March 18, 2024

Huber Heights New Public Works Facility

### **ADDENDUM #1**

**1A101.1**

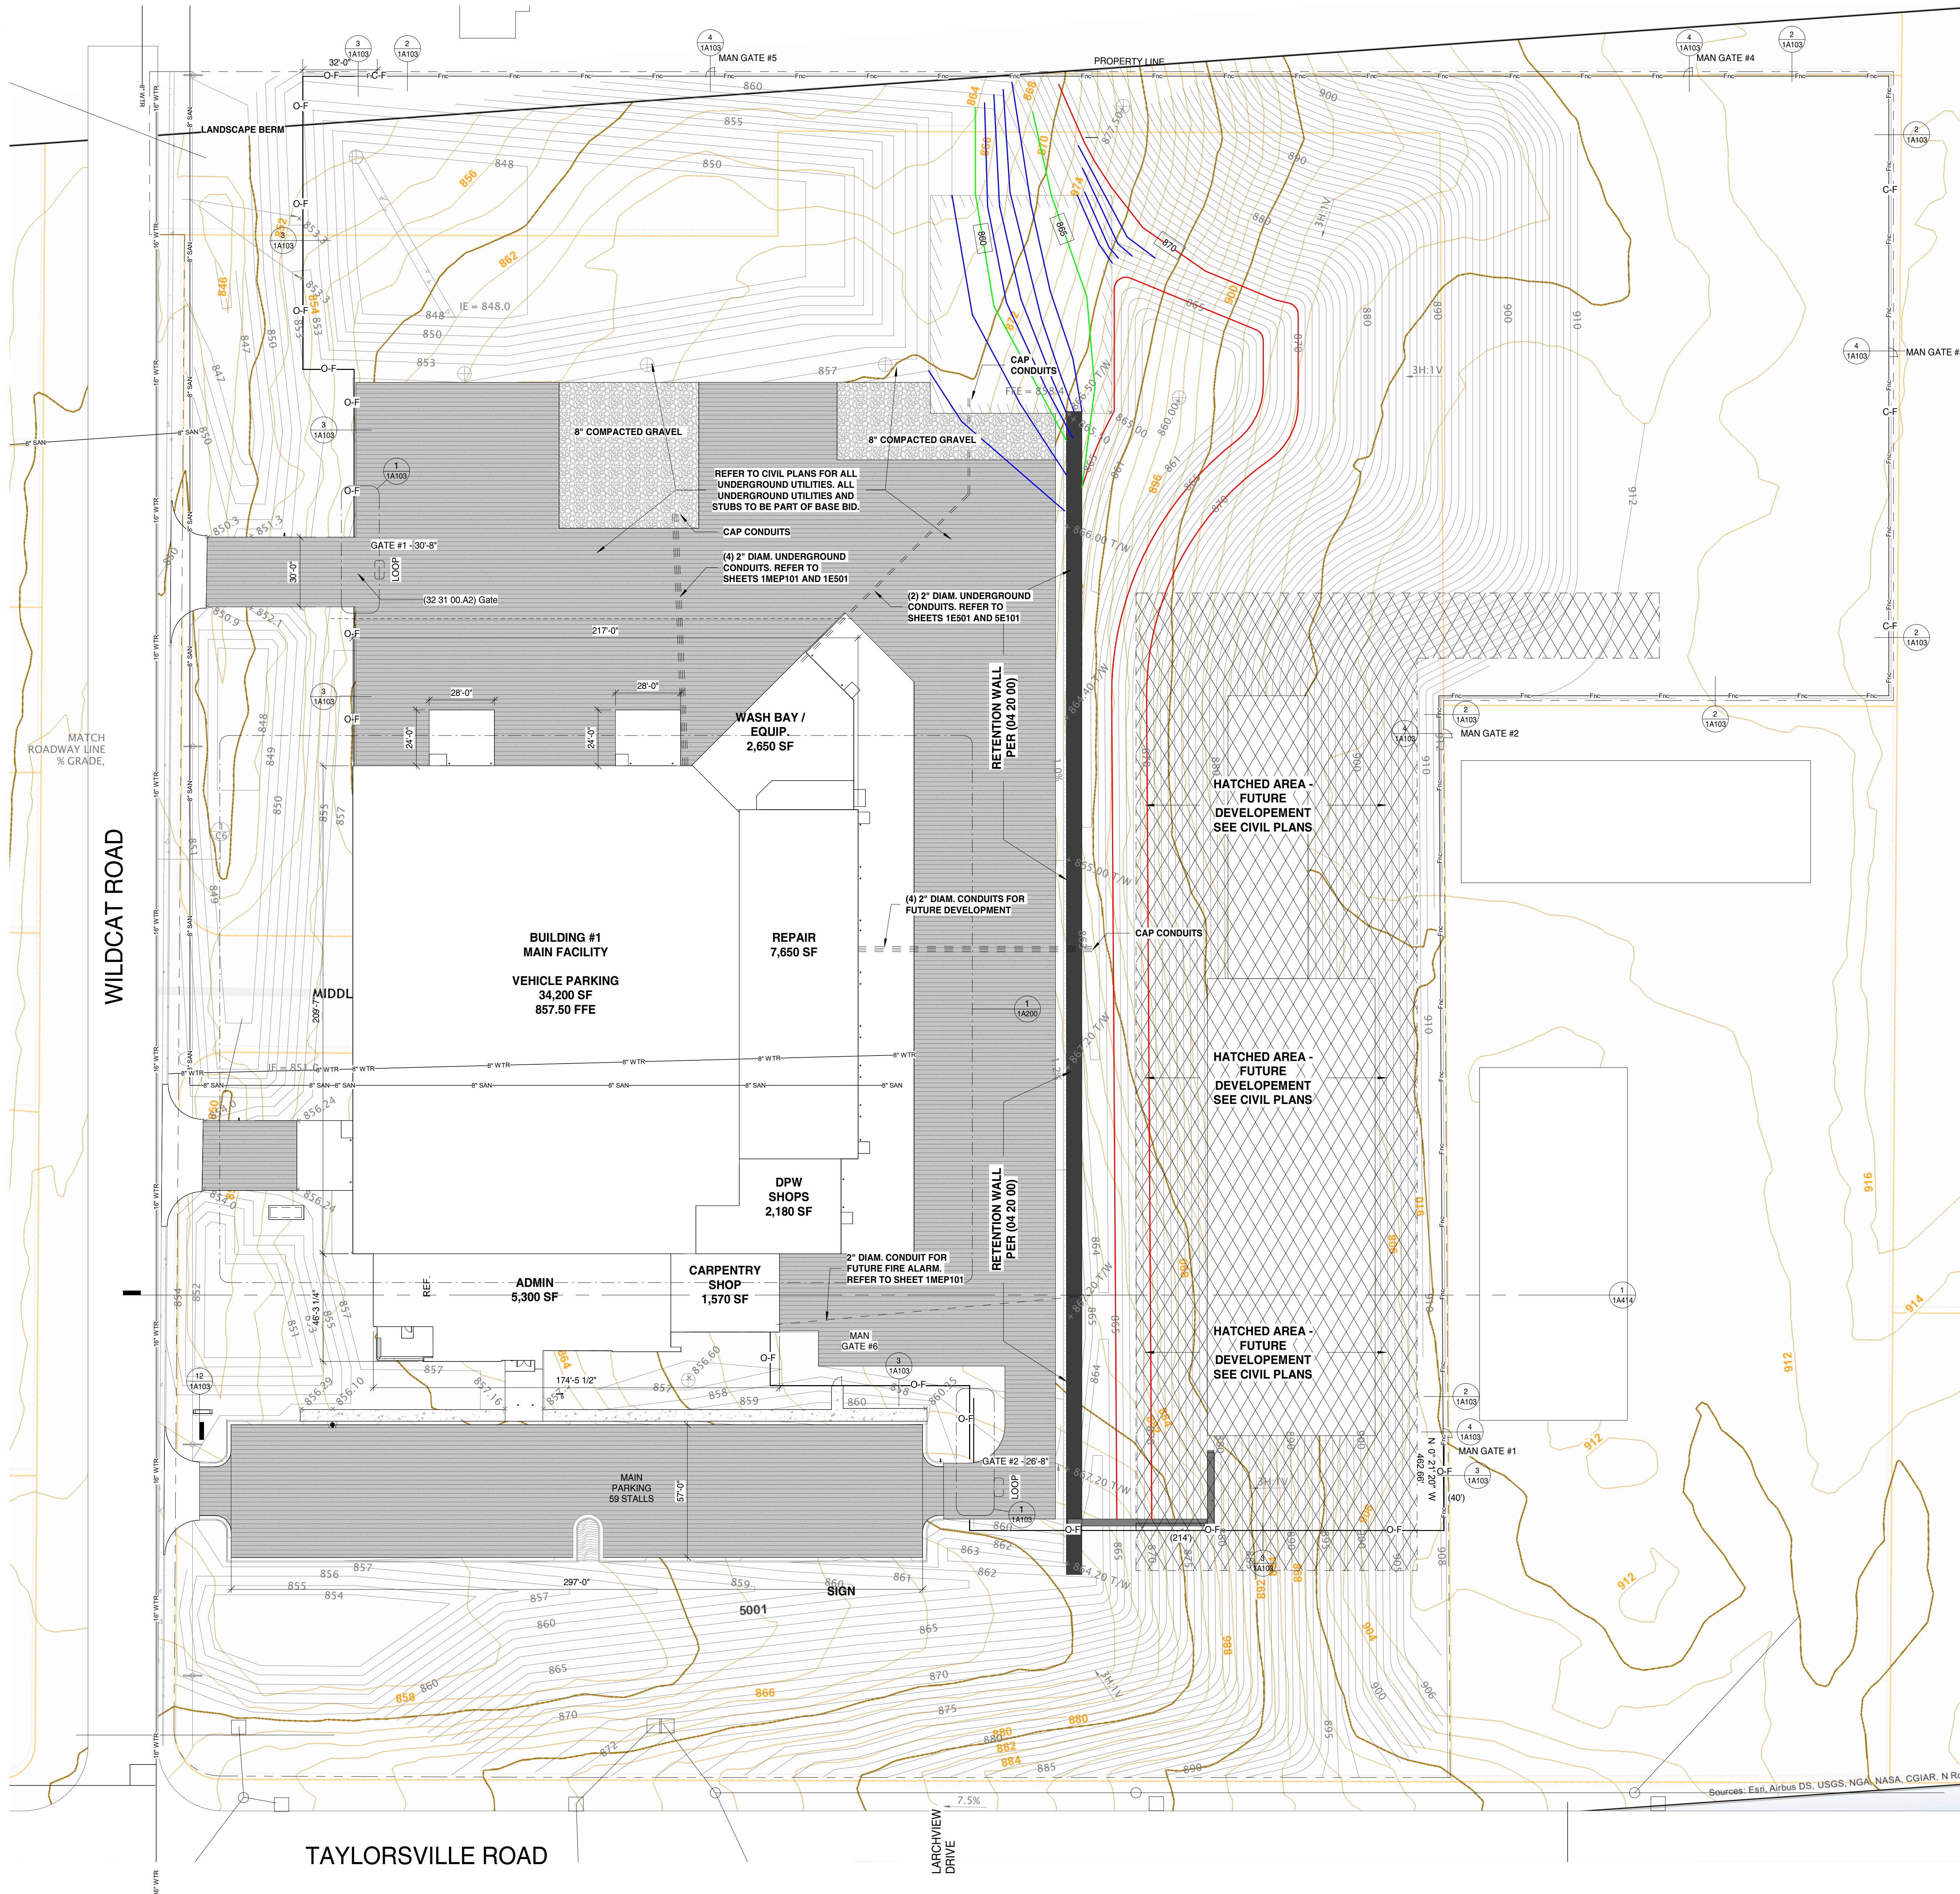
- a. Yes, include (4) 2" Conduits for future/owners use between main building and future development. Refer to 1MEP101 and 1E501.
7. ***Drawing Sheet S1IT101: Sheet references stub piping for future development, what size and quantity of piping is required? Please provide information.***

- a. See the attached Base Bid site plan drawing for added notes and clarity.
8. ***Is there a budget for this project? Does that budget include the alternates? Does the City of Huber Heights have any rules or requirements for awarding if the bids come in over budget?***

**1E501**

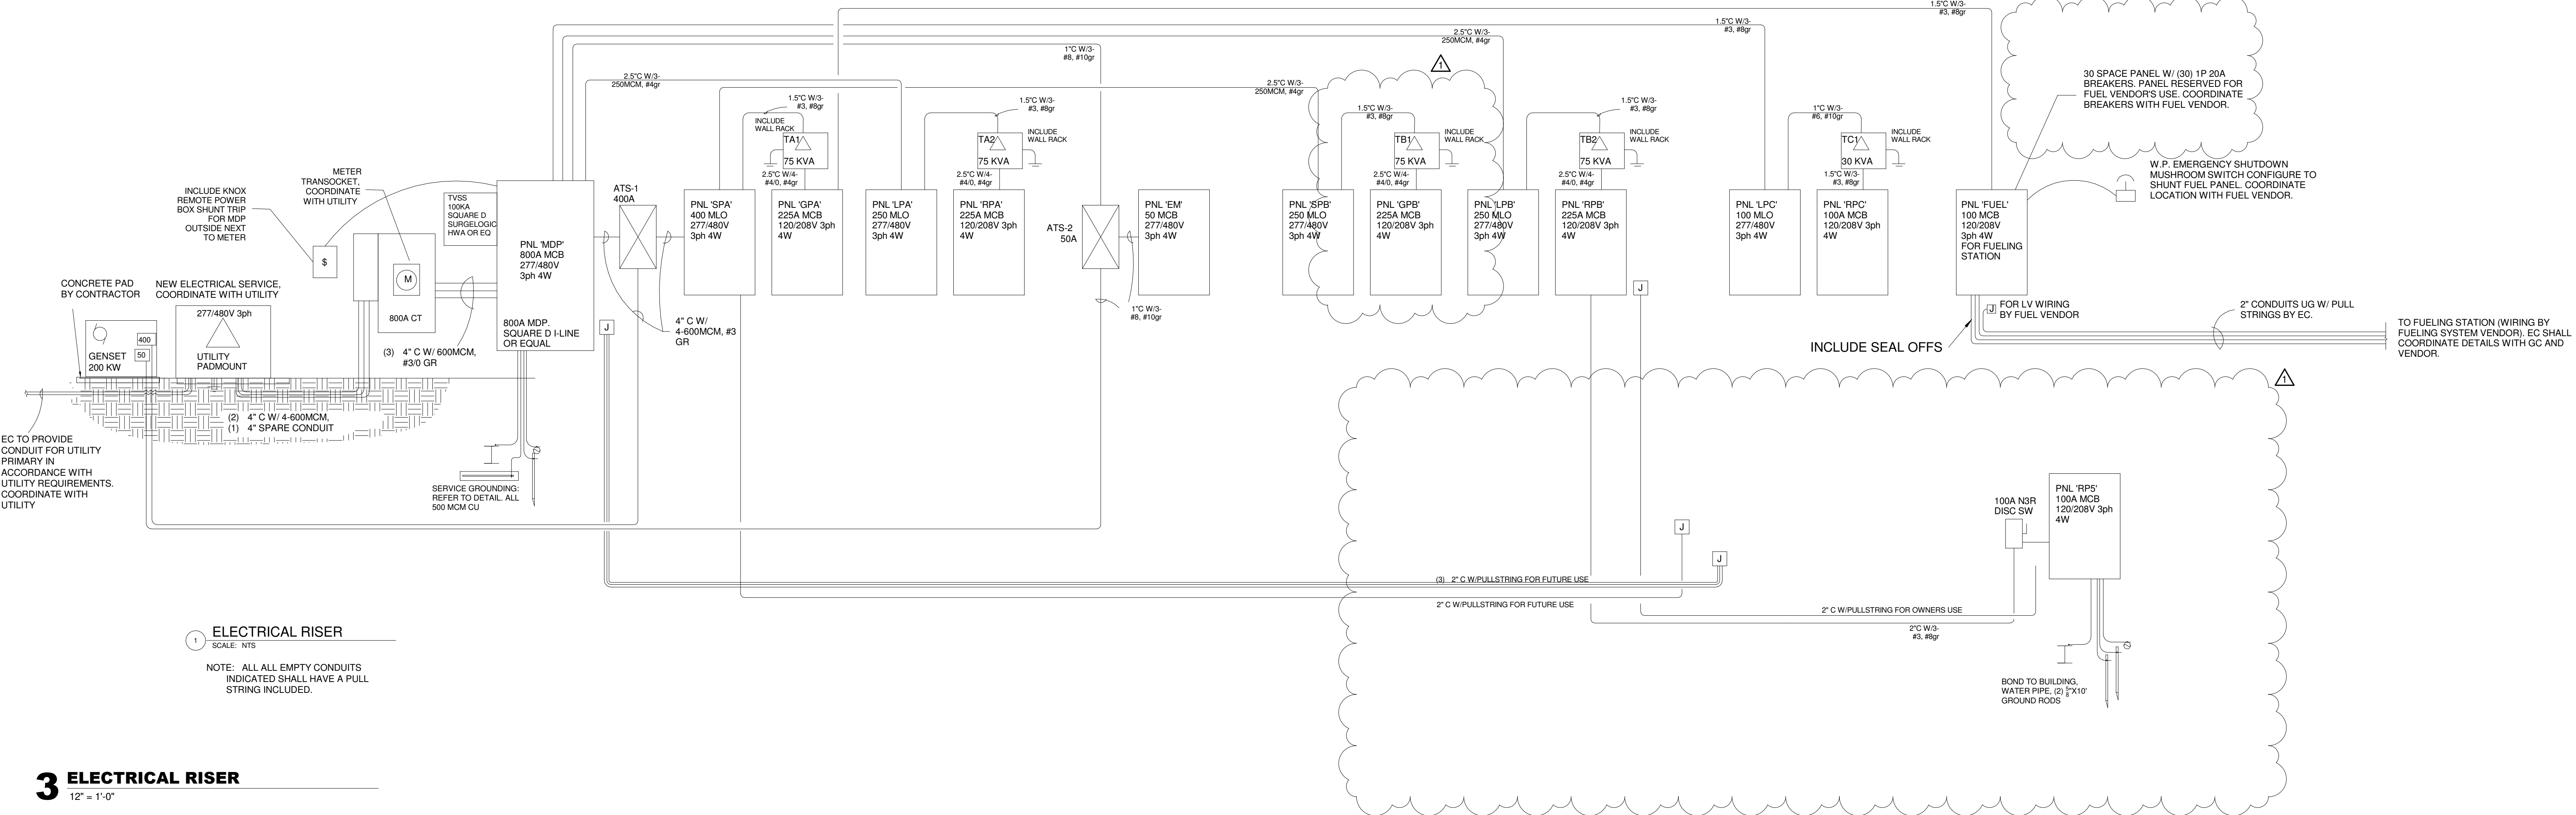
- The wall is noted on the civil drawings and the specification is 04 20 00 for the material to be used.
- 13. Sheet 1E501: The feed from the Utility Transformer to the CT Cabinet, and from the CT Cabinet to 'MDP' shows three parallel runs of 600MCM. Two parallel runs of 600MCM would be sufficient for the 800A service per NEC. Please advise.**

- LPC/TC1 to be located next to panel RPC on sheet 1E303. TS, SP2, and GP2 removed from scope. Refer to updated sheet 1E501.
- 15. Panel Schedules are missing for 'FUEL' and 'LPC', please provide?**

- Panel SPA to be MLO as noted in one-line on sheet 1E501.
- 24. Panel GBP schedule shows this as a 225A, but the one-line shows it to be 100A. Please advise.**

- Panel GBP to be 225A MCB as shown on panel schedule. TB1 to be 75kVA, refer to 1E501.
- 25. Need more information on Power Washer circuit and disconnect.**

- Include (2) 4" C w/ 4-600MCM, include spare 4" conduit.
- 14. The location of branch panels 'LPC', 'SP2', & 'GP2' as well as transformers 'TC1' & 'TS' are not shown on the electrical drawings. Where are these located?**

**1E302**

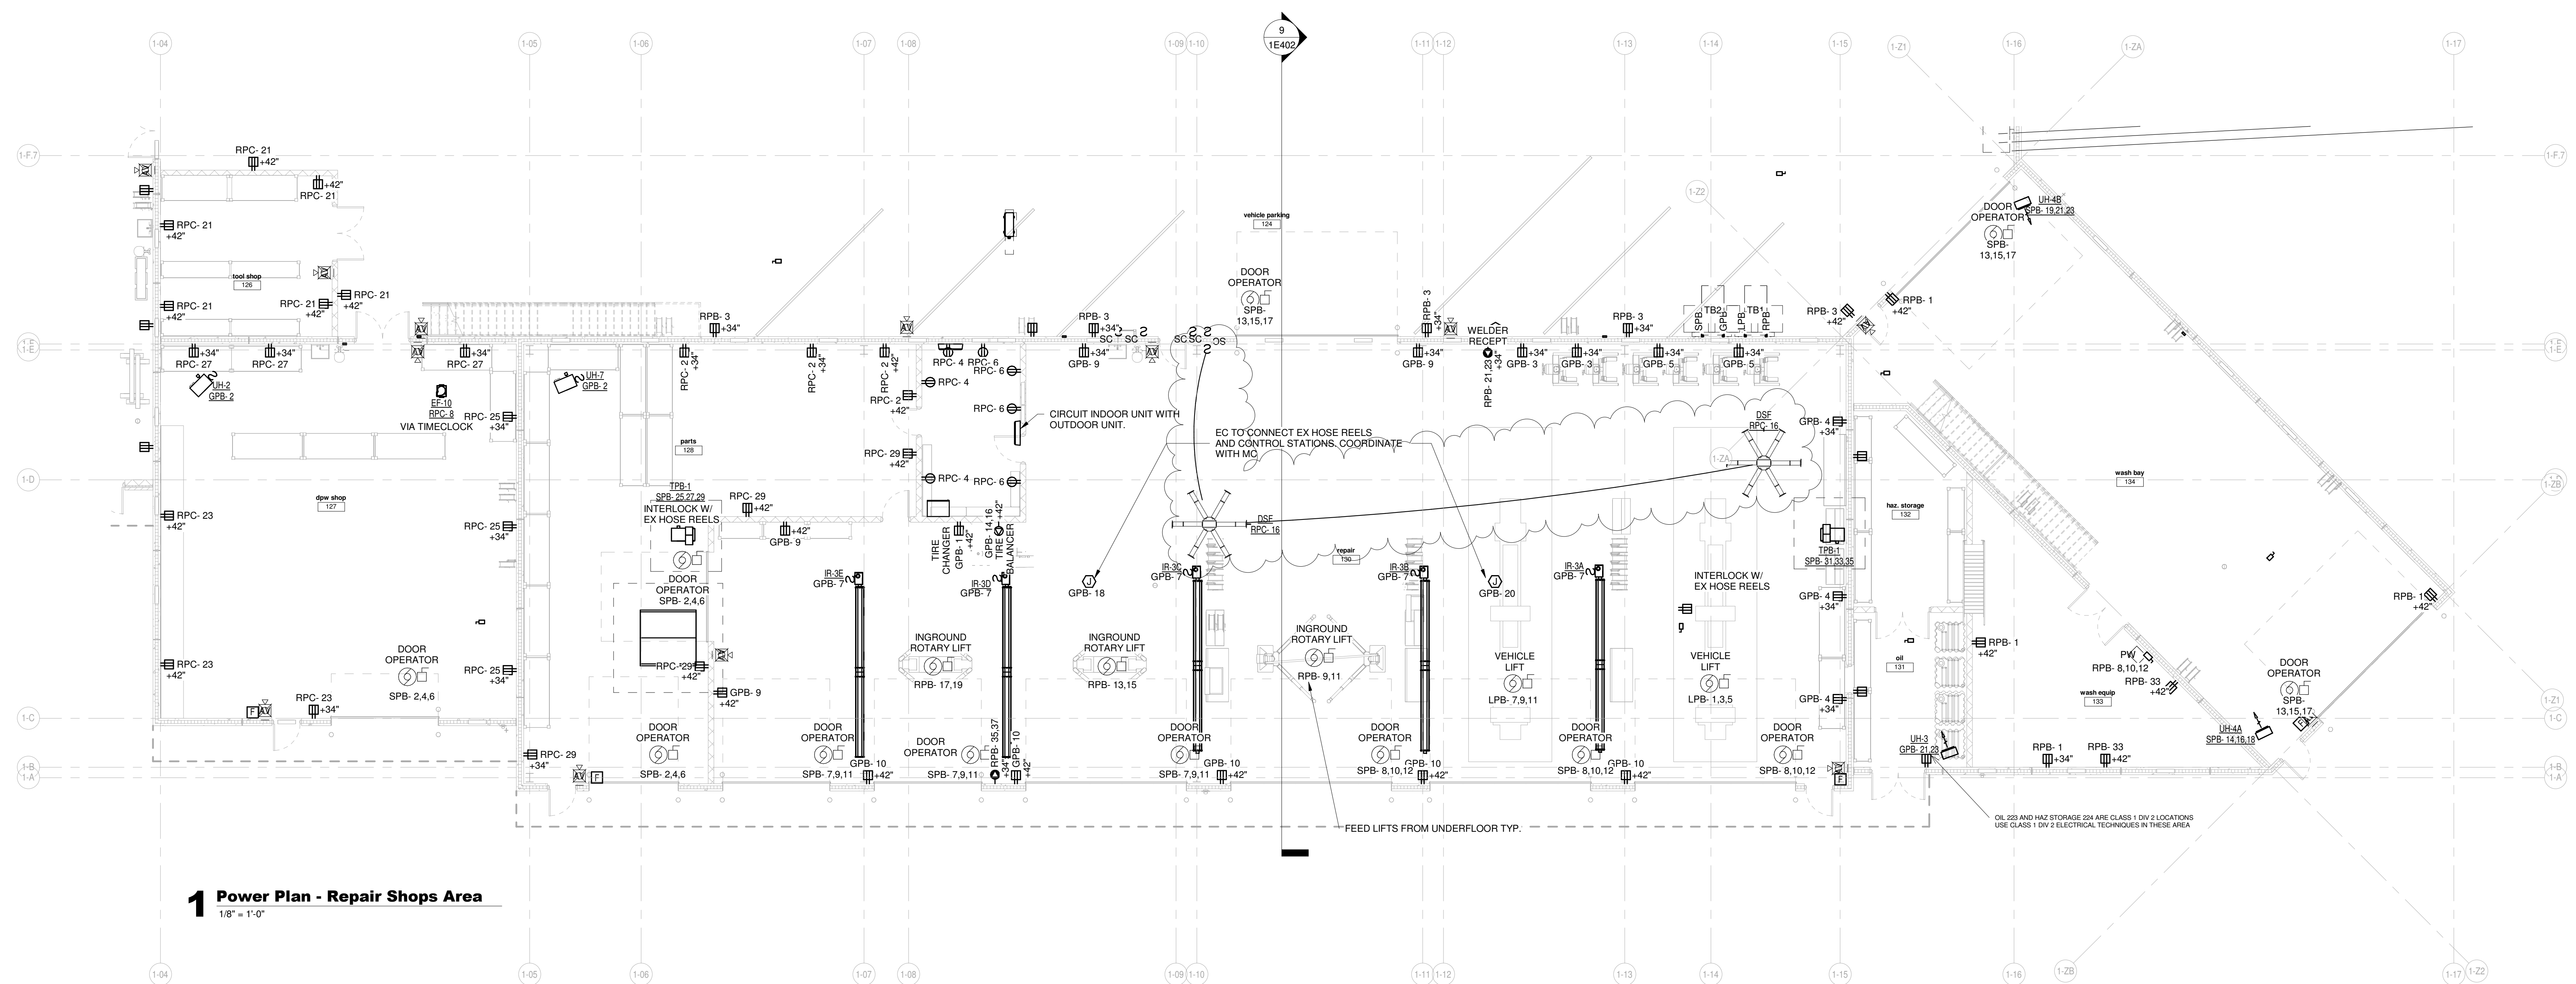
- a. As noted above, the basement alternate is 17.5 million and the city does follow a 25% rule.
9. ***Drawing Sheet 1M103 & 1M104: These two drawings show a total of (14) DSF Fans which have been added to the Mechanical scope of work and the equipment requirements for the DSF fans was added to drawing 1M201. Please provide this scope of work with the required circuitry on the electrical drawings.?***

- a. Refer to sheet 1E302/1E303 for electrical scope for DSF Fans.
10. ***Drawing Sheet 1E301: Electrical sheet does not show the IDU-1-9 unit any longer on the drawing, but this unit is still on Mechanical drawing 1M102 and on equipment schedule drawing 1M203. If this unit is required, please provide this scope of work information on the electrical drawings.***
